February 5, 2013

**Subject: Model Water Quality Management Plan and Technical Guidance Document Errata;  
Order No. R8-2009-0030**

# TECHNICAL GUIDANCE DOCUMENT ERRATA SHEET #2

## FEBRUARY 5, 2013

FIGURE  
XVI-3b

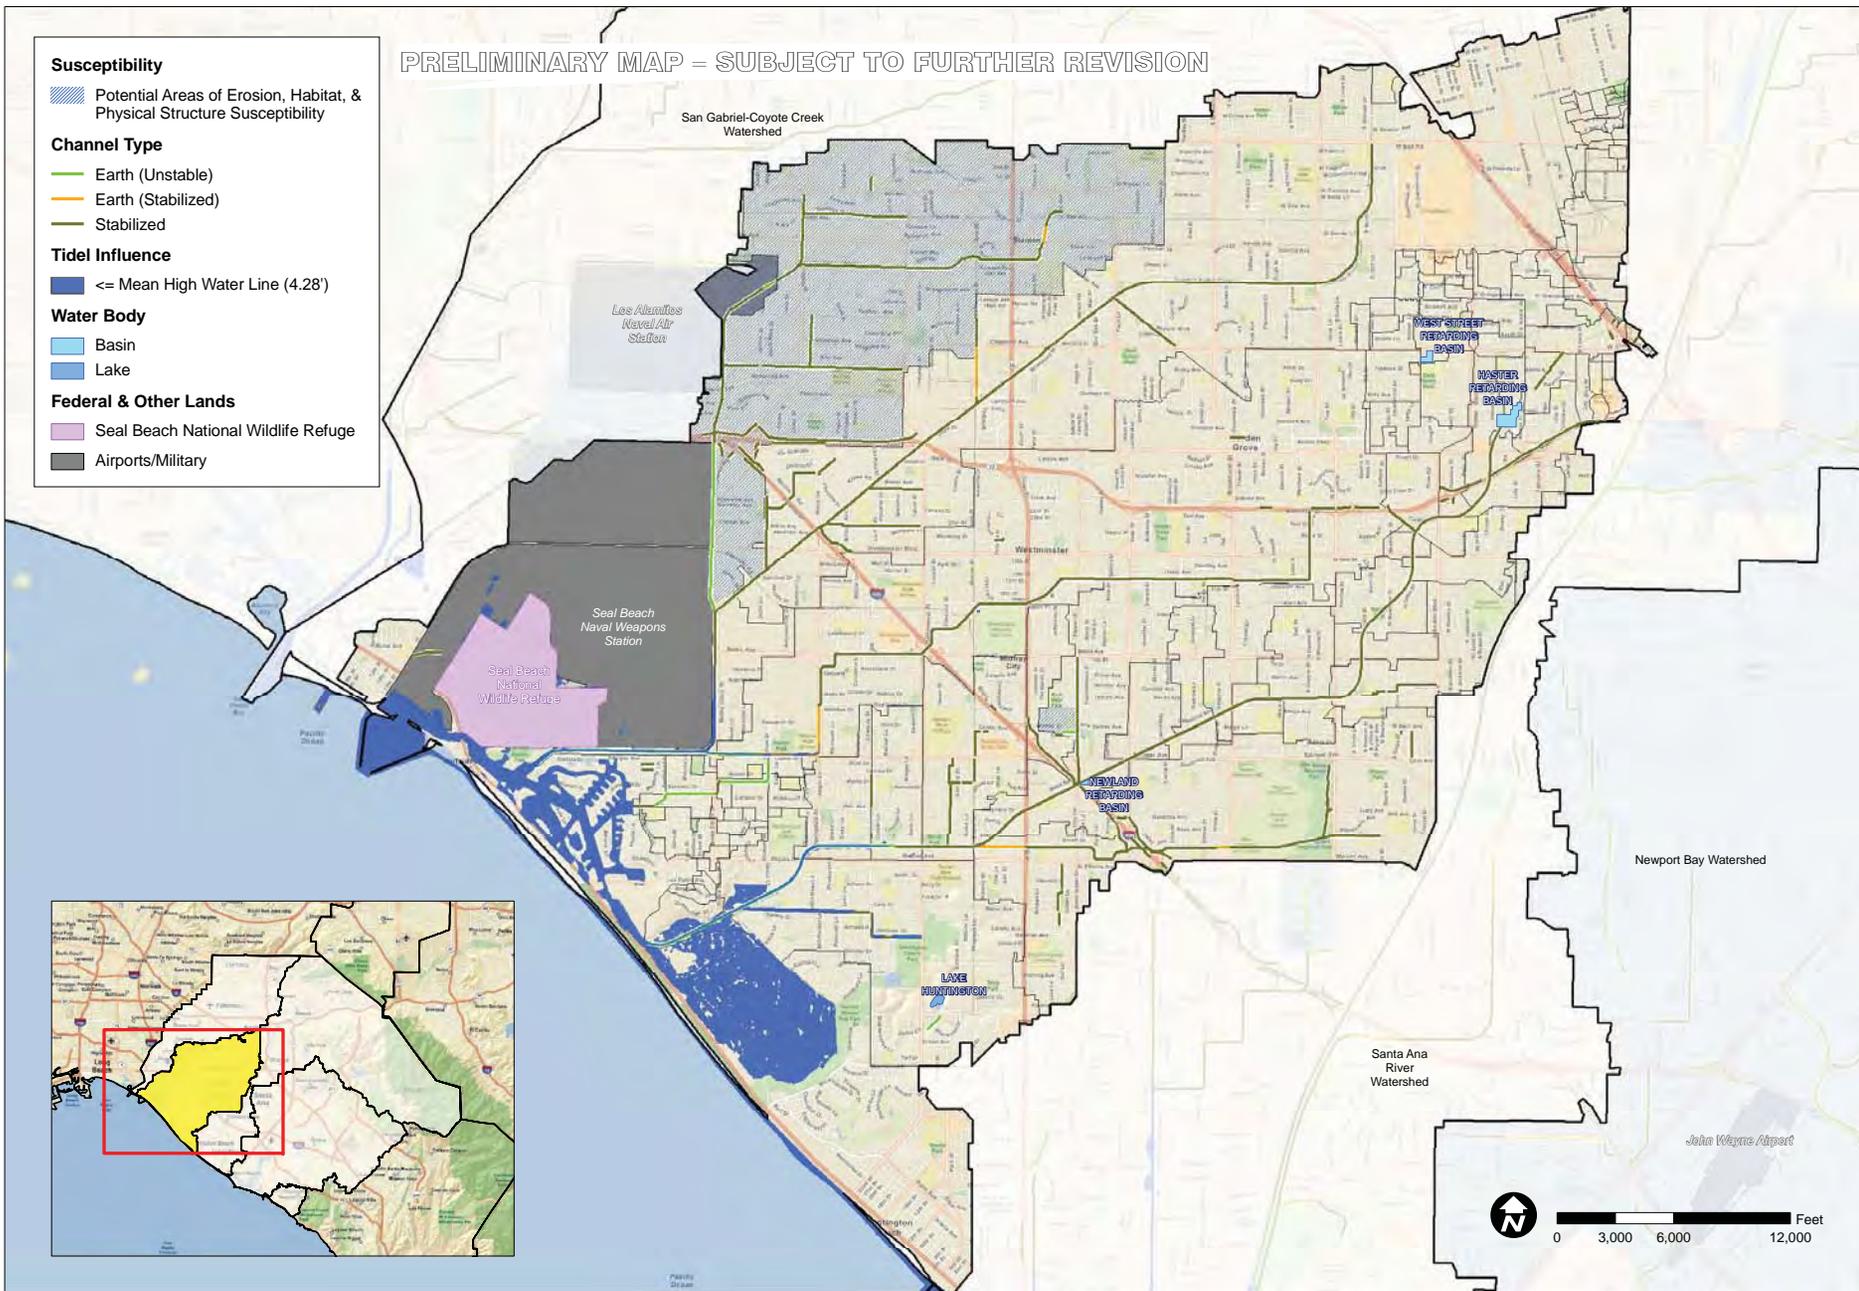
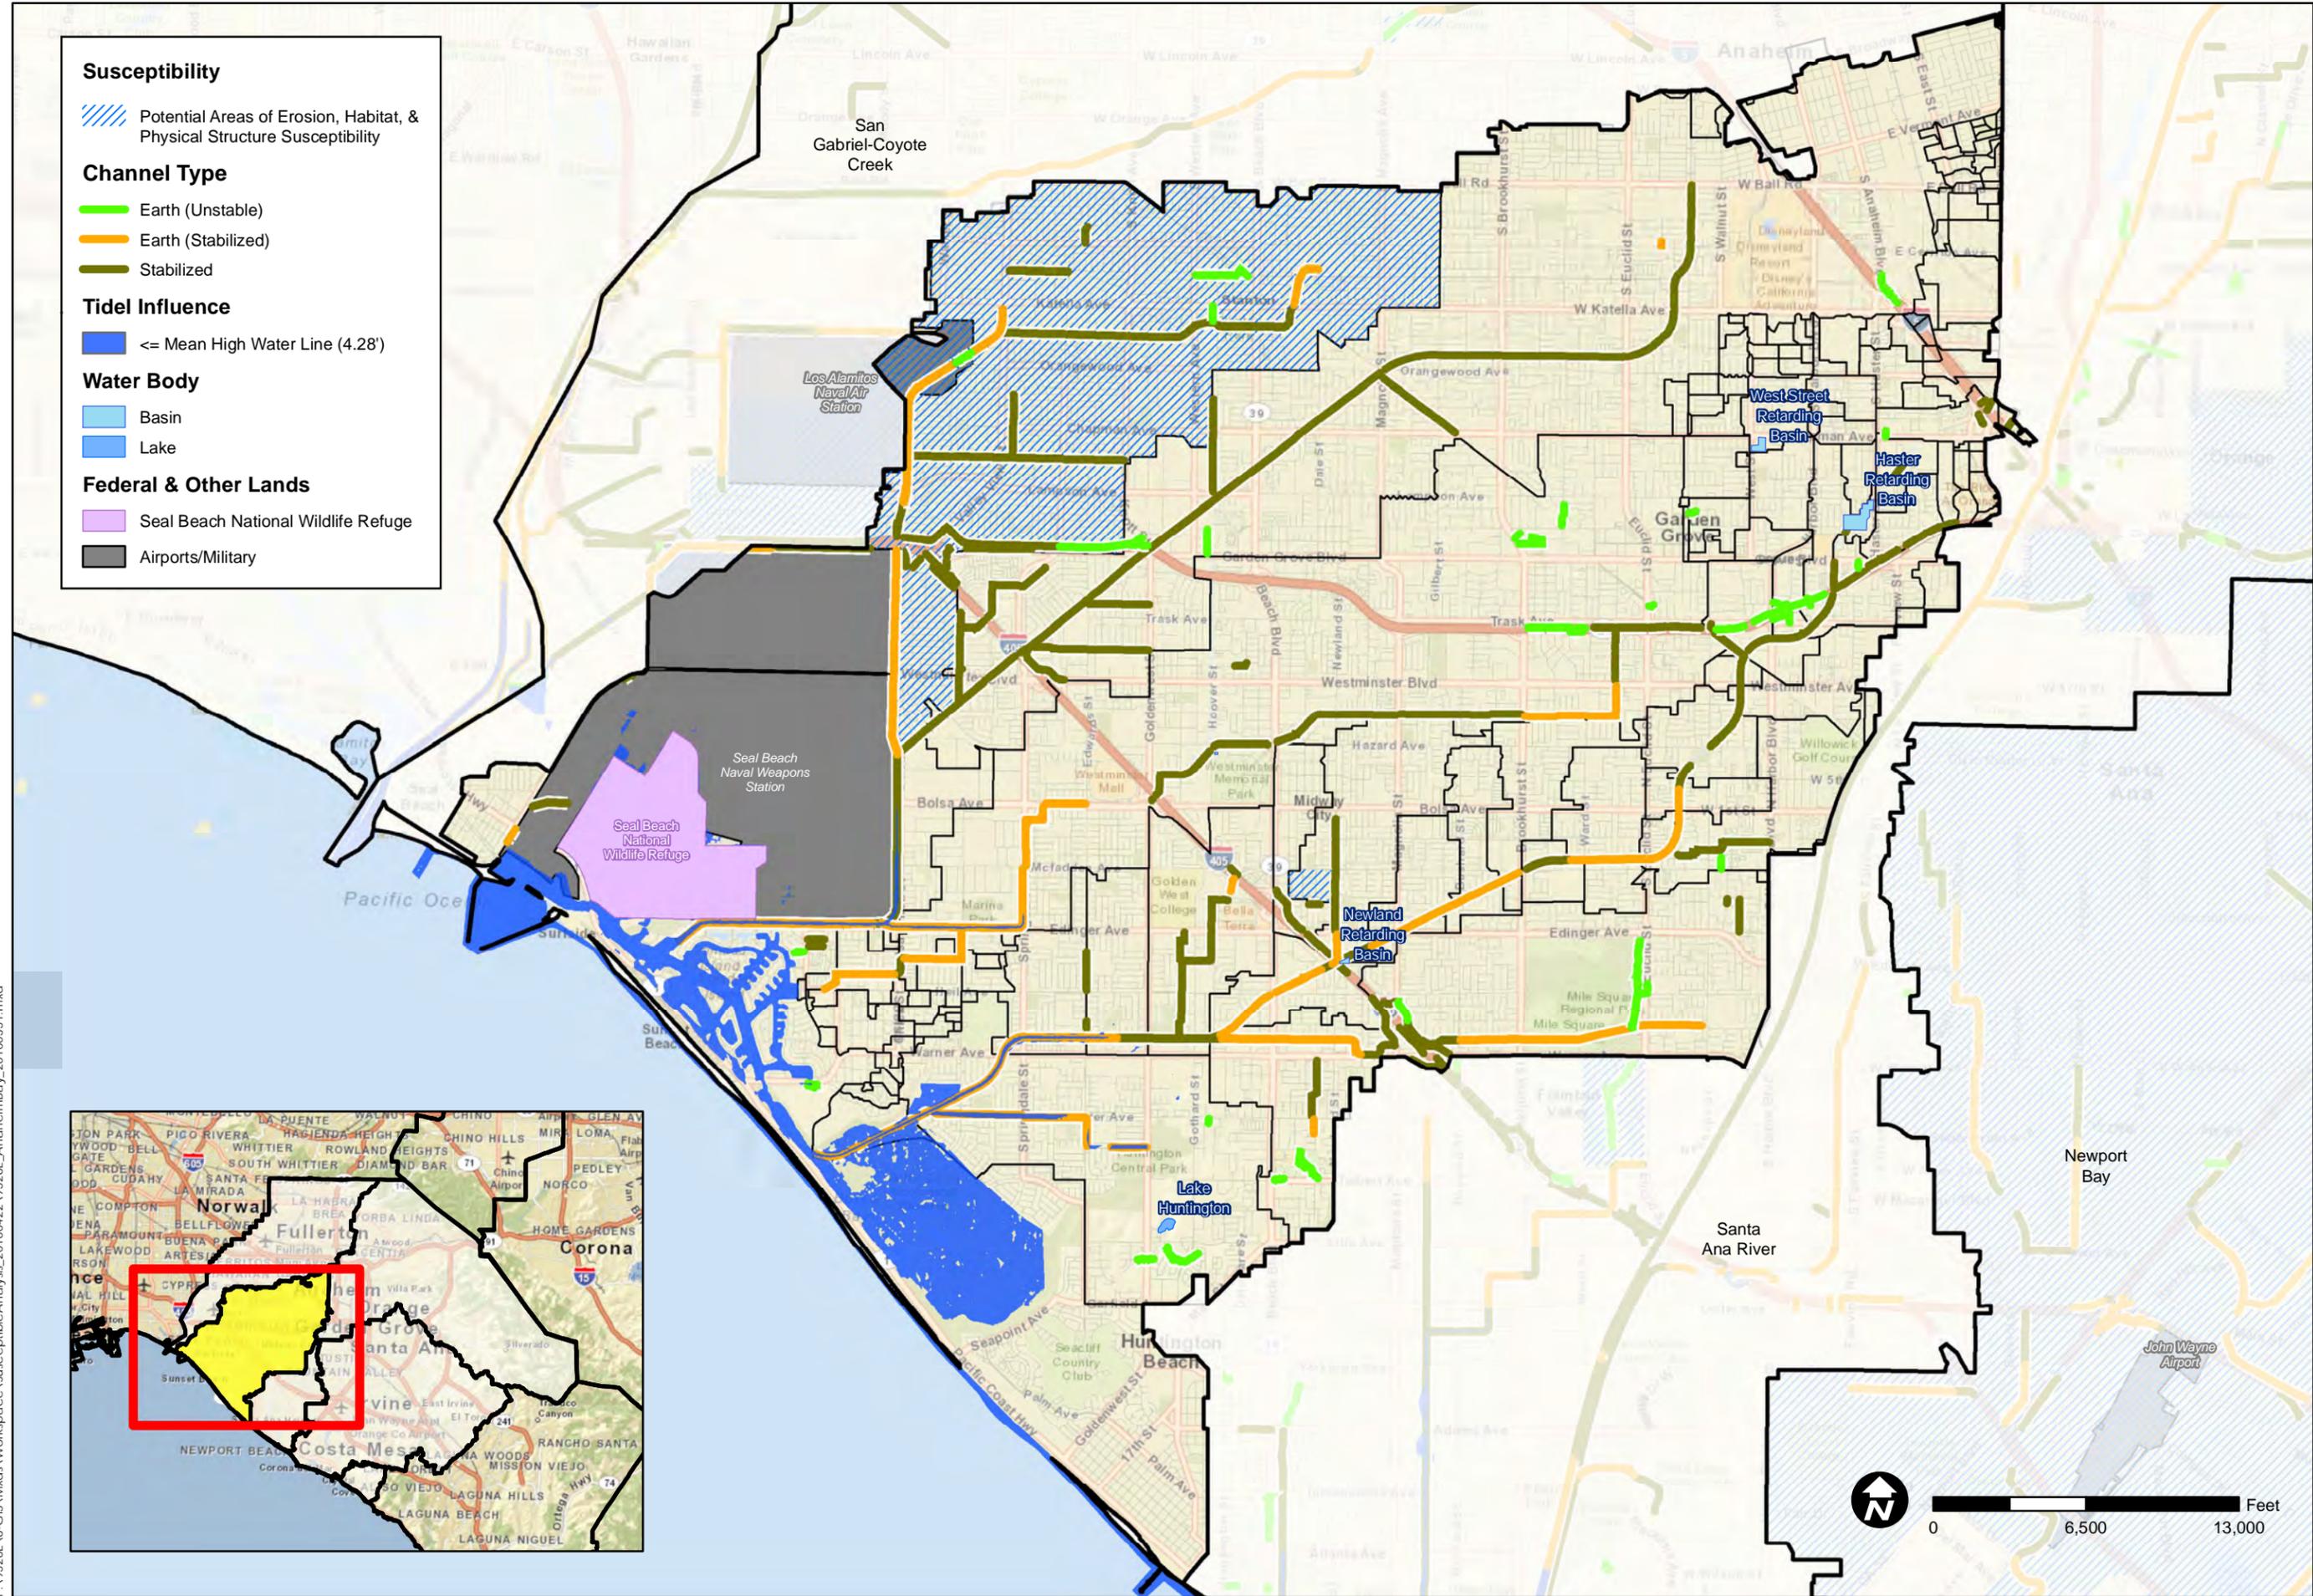
- A total of 9,612 linear feet of channel changed from Earth (Unstable) to Earth (Stabilized)
- Channels:
  - OCEAN VIEW CHANNEL = 1,358 ft.
  - EAST GARDEN GROVE-WINTERSBURG CHANNEL = 2,684 ft.
  - BOLSA CHICA CHANNEL = 2,249 ft.
  - SLATER STORM CHANNEL = 304 ft.
  - STANTON STORM CHANNEL = 175 ft.
  - WESTMINSTER CHANNEL = 1,517 ft.
  - SUNSET CHANNEL = 597 ft.
  - NEWLAND STORM CHANNEL = 119 ft.
  - Unnamed Channels = 609 ft.
